Final Walkthrough Checklist (New Home)

Prepared for	J. and M. Okafor
Date	20 Oct 2026
Site	2318 Larkspur Glen Drive, Raleigh
Prepared by	D. Halvorsen

Project	2318 Larkspur Glen Drive, Raleigh: final walkthrough (completed example)
Home address	2318 Larkspur Glen Drive, Raleigh, NC 27610
Buyer	J. and M. Okafor
Location (GPS)	35.7531, -78.5612
Walkthrough date	20 Oct 2026
Walk led by	D. Halvorsen, construction manager
Community, lot or job number	Wakefield Bend, lot 47
Builder	Piedmont Crest Homes LLC
Buyers present	J. Okafor, M. Okafor
Others present	R. Tull, superintendent
Type of walk	Final walkthrough before closing
Closing date	30 Oct 2026
Building department final inspection passed?	Yes
Certificate of occupancy or permit reference	Certificate of occupancy issued 2026-10-15, permit BLD-26-08841

Tape number or item	Tape 4
---------------------	--------

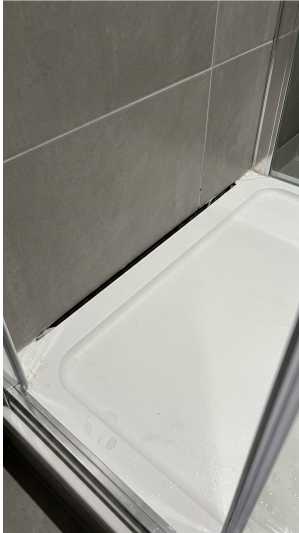
Exactly where	Shower base, back edge
What is wrong	Caulk line along the back of the shower base has a gap.
Trade to fix it	Tile

Buyer and builder agree it needs fixing?	Yes
Fixed?	Yes
Date fixed	22 Oct 2026
Buyer has seen the fix and accepts it?	Yes
This room: items taped	2
Fixed	1
Agreed, still open	1
